AMENDMENT DRAWING

AMENDMENT DRAWING

Project Title: VA PUGET SOUND HEALTH CARE SYSTEM UPGRADE SEATTLE ELECTRICAL DISTRIBUTION FROM 5kV TO 15kV

Drawing Number: 001-EP102R

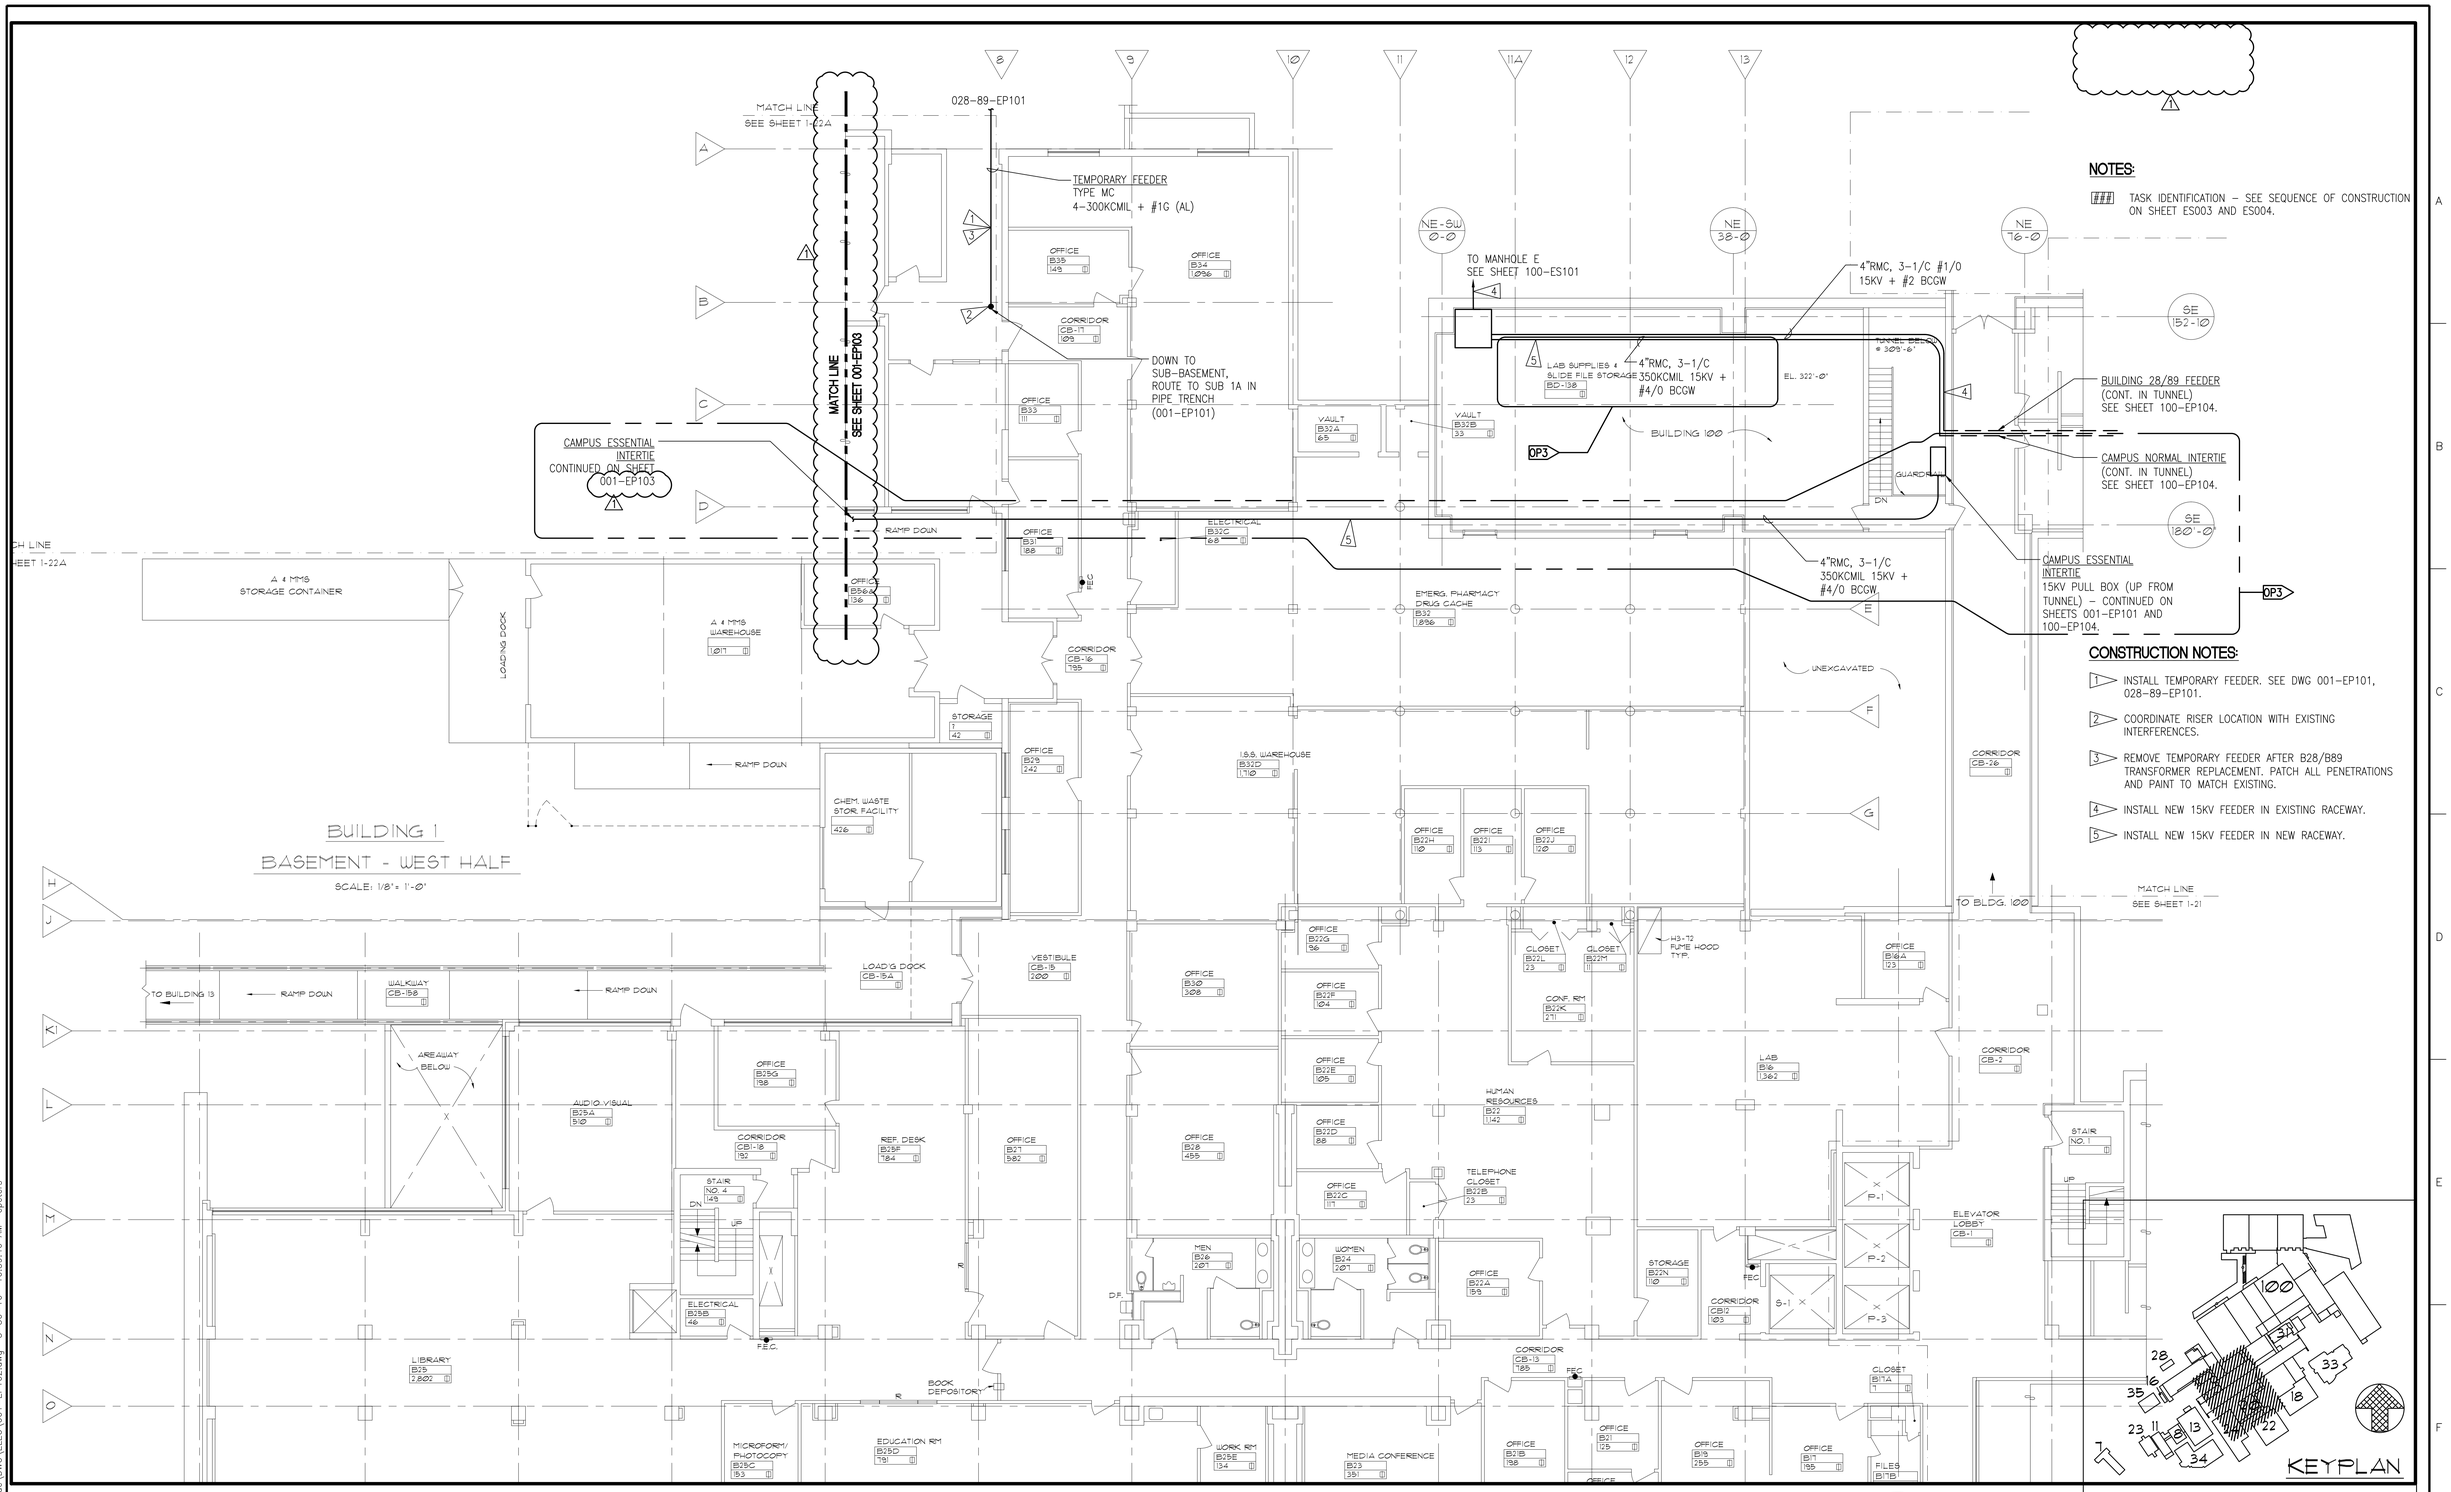
1. INSTALL TEMPORARY FEEDER. SEE DWG 001-EP101, 028-89-EP101.
2. COORDINATE RISER LOCATION WITH EXISTING INTERFERENCES.
3. REMOVE TEMPORARY FEEDER AFTER B28/B89 TRANSFORMER REPLACEMENT. PATCH ALL PENETRATIONS AND PAINT TO MATCH EXISTING.
4. INSTALL NEW 15KV FEEDER IN EXISTING RACEWAY.
5. INSTALL NEW 15KV FEEDER IN NEW RACEWAY.

Drawing Number: 016-EP101R

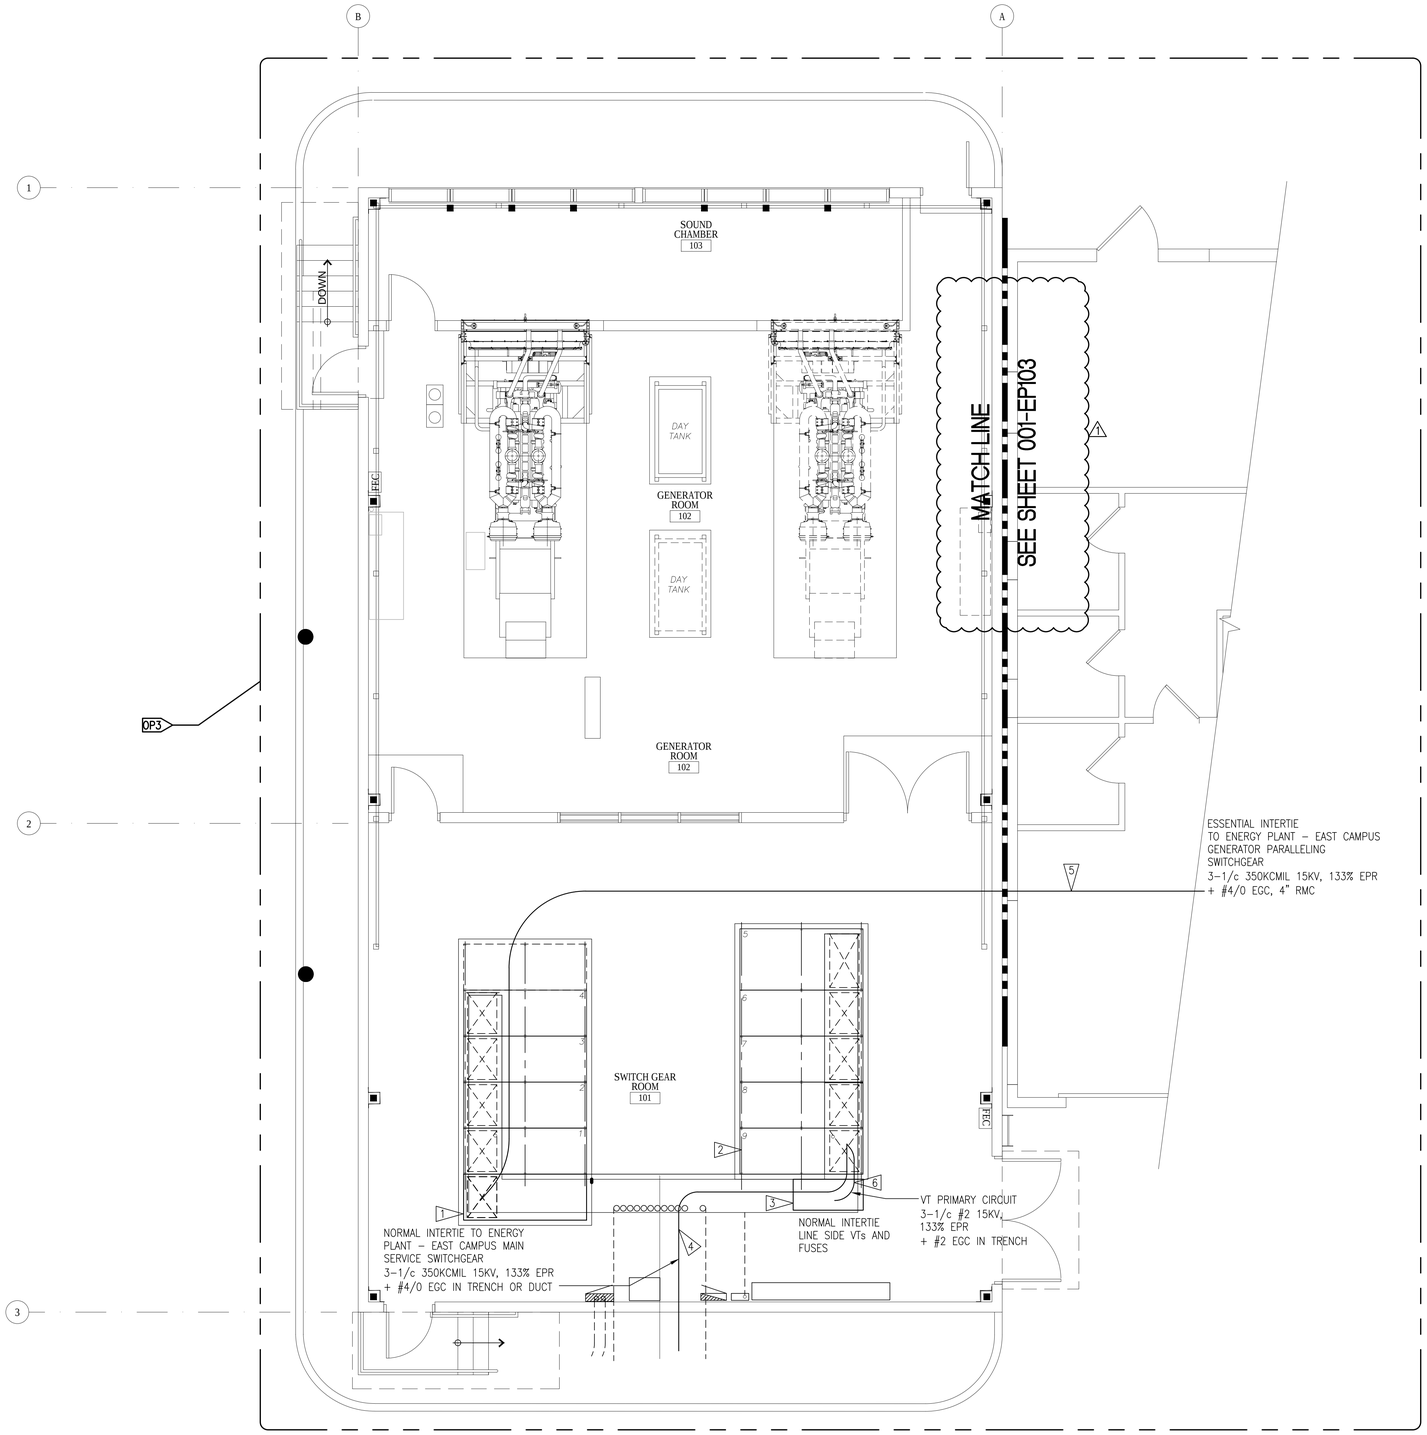
1. PROVIDE AND INSTALL NEW SWITCHGEAR SECTION. EXTEND BUS FROM ADJACENT SECTION TO NEW SECTION.
2. INSTALL NEW BREAKER, CURRENT TRANSFORMERS AND RELAY IN SPARE CUBICLE OF EXISTING SECTION.
3. PROVIDE AND INSTALL VOLTAGE TRANSFORMER CABINET WITH PRIMARY FUSES. INSTALL TRANSFORMER SECONDARY CONNECTIONS TO NEW RELAY IN ADJACENT CABINET.
4. INSTALL NEW 15KV FEEDER IN EXISTING TRENCH, AND SPARE DUCT TO MANHOLE H.
5. INSTALL NEW 15KV FEEDER AS SHOWN.
6. INSTALL VOLTAGE TRANSFORMER PRIMARY CONNECTION IN TRENCH. TERMINATE AT BREAKER LUGS.
7. LABEL TAP BOX AND VOLTAGE TRANSFORMER CABINET WITH "DO NOT OPEN WHILE NORMAL INTERTIE FEEDER IS ENERGIZED."

Drawing Number: 016-EP601R

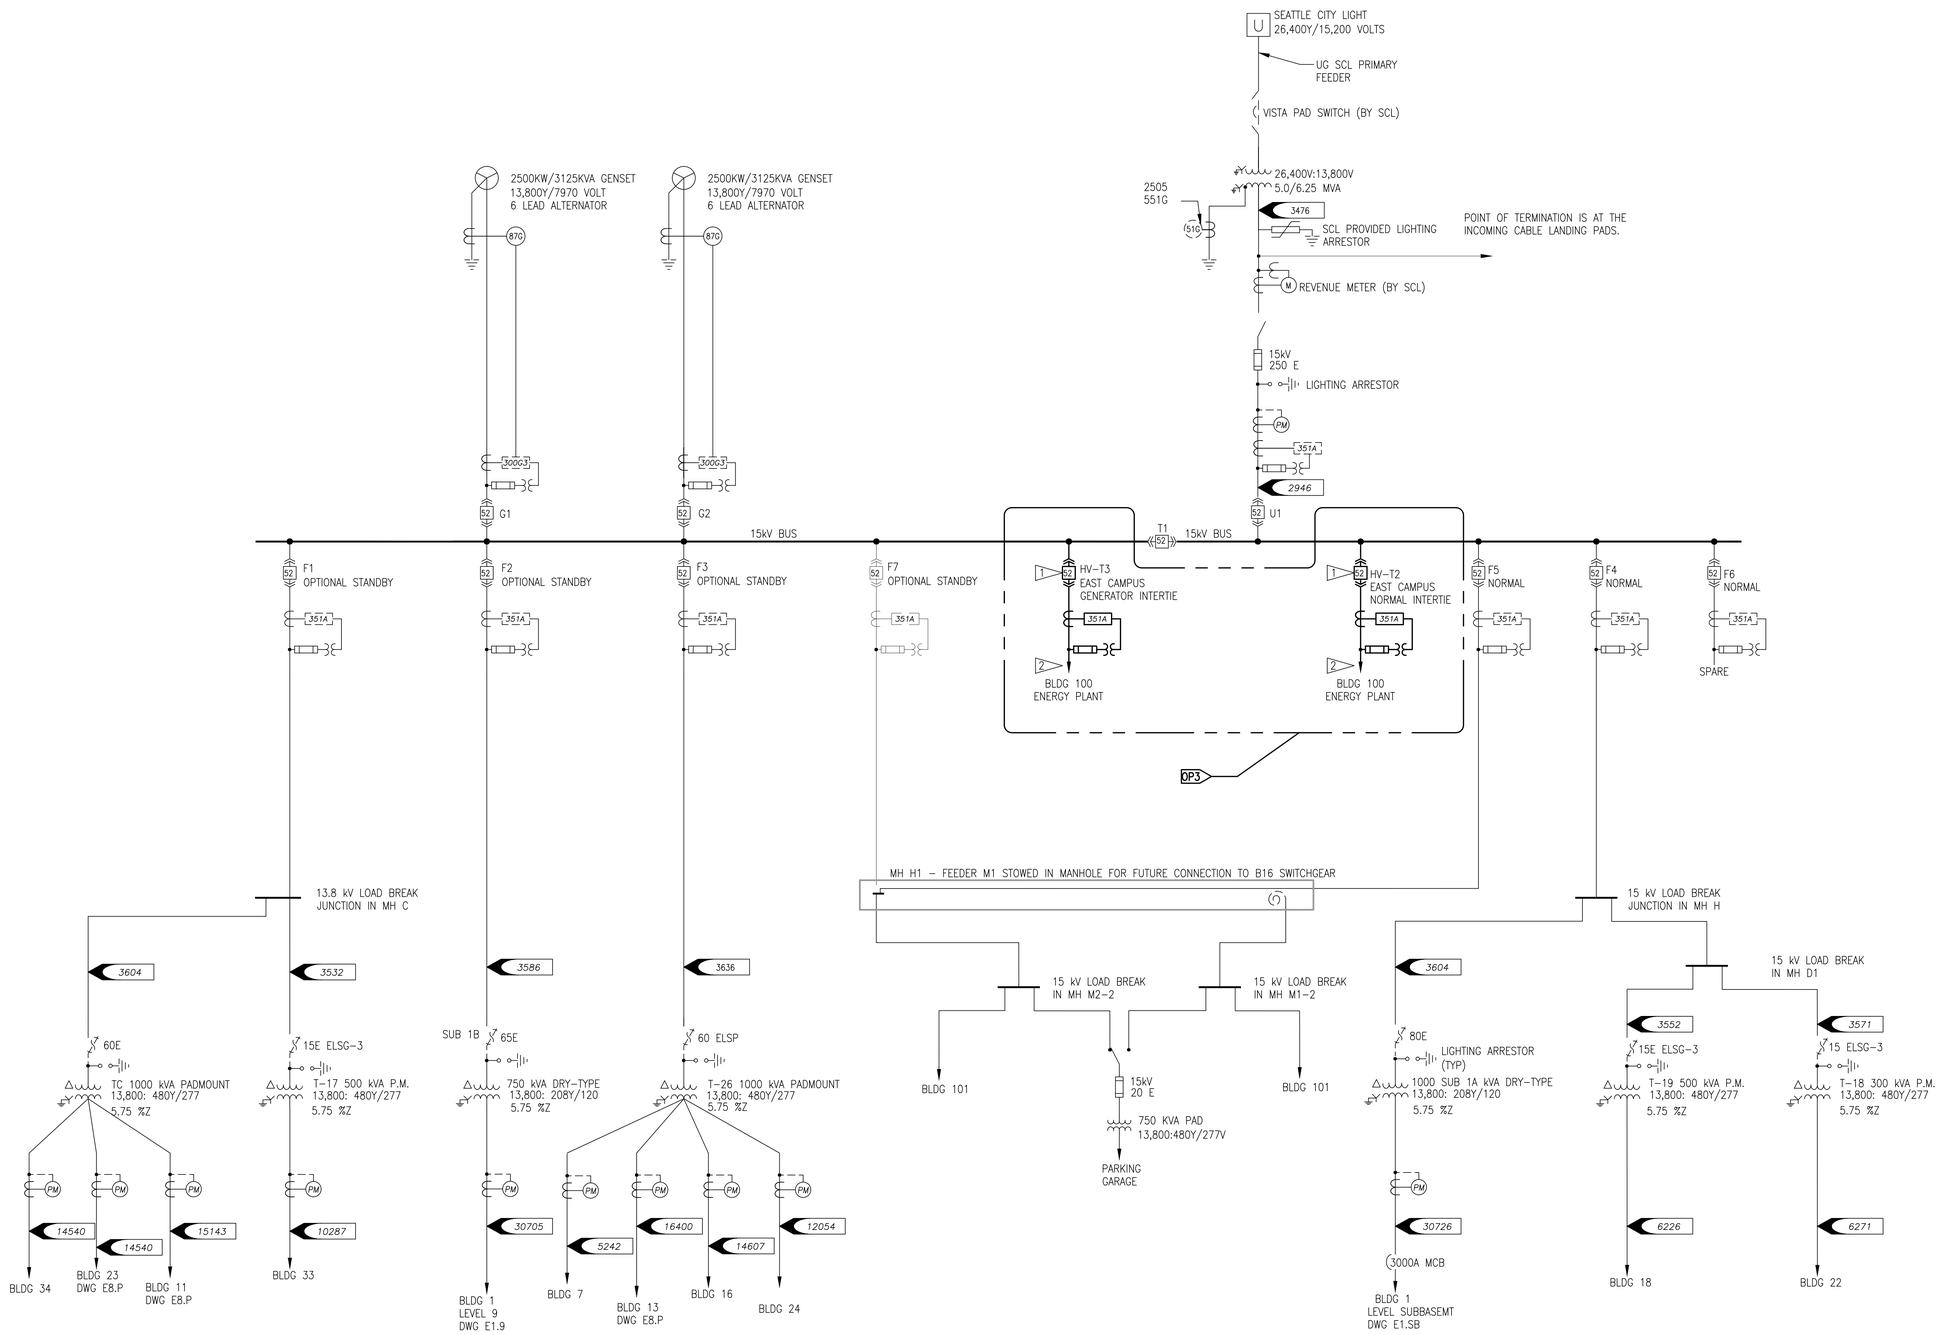
1. INSTALL NEW BREAKER.
2. INSTALL NEW 15KV FEEDER.

Drawing Number: 028 89-ED601R

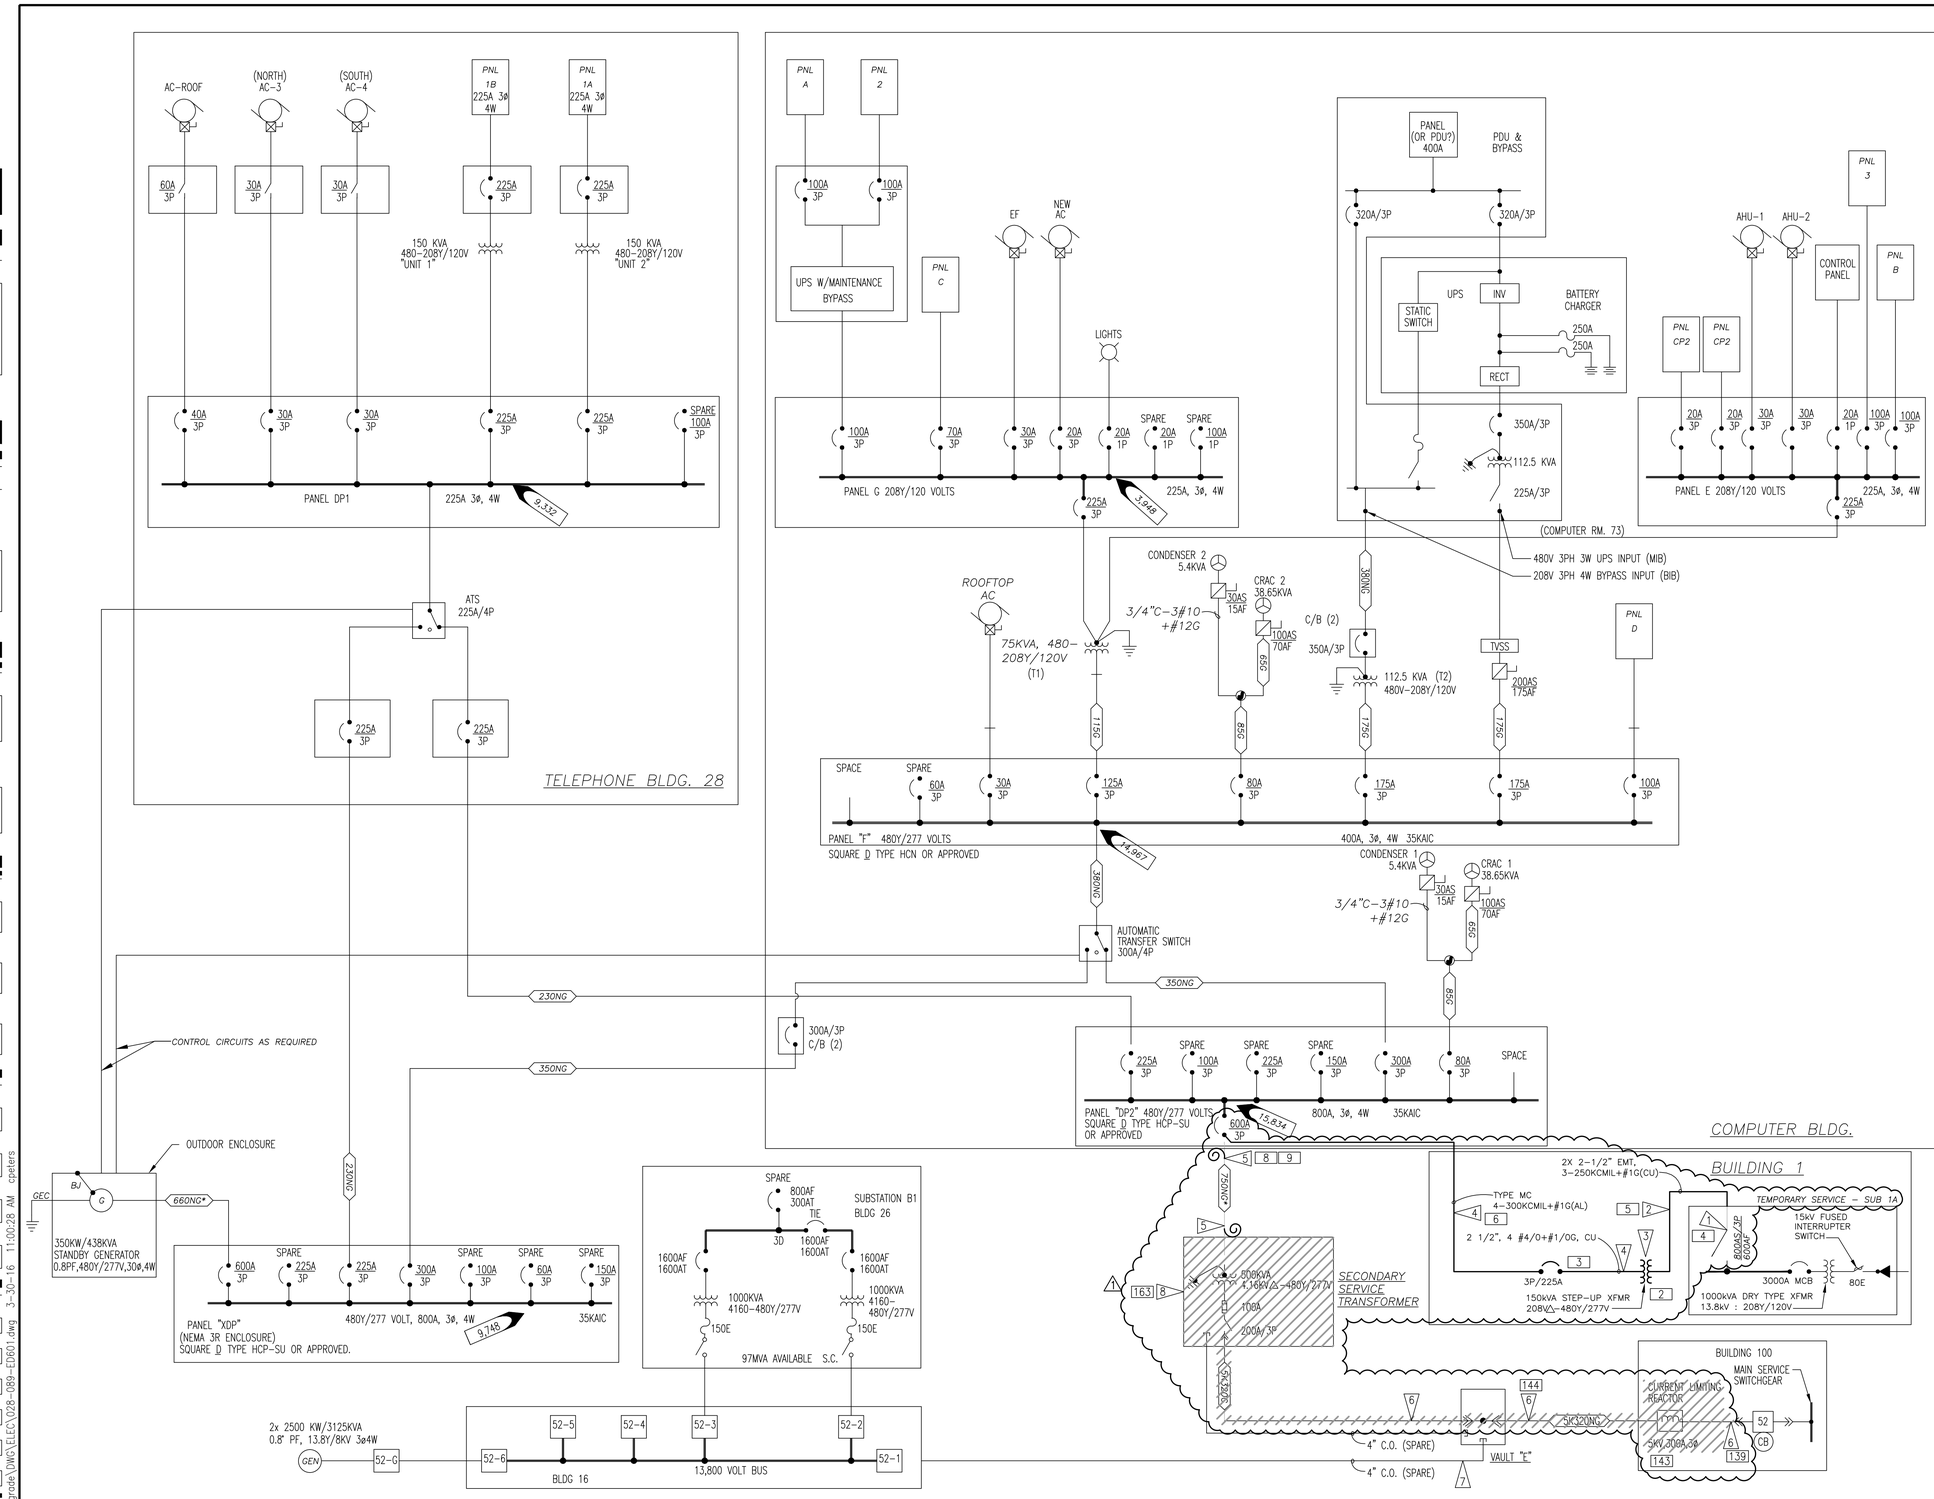
1. RE-FUSE SPARE SWITCH, SEE DWG B01-EP101.
2. NEW 208V FEEDER.
3. PROVIDE 150KVA STEP-UP TRANSFORMER.
4. NEW 480KV FEEDER TO BLDG 28/89.
5. DISCONNECT EXISTING 480 FEEDER, PROTECT FOR RE-USE.
6. REMOVE 5KV FEEDER CONDUCTORS.
7. REMOVE 5KV FEEDER CONDUCTORS IF PRESENT BETWEEN MANHOLE "E" AND MANHOLE "H"
8. REMOVE TRANSFORMER.
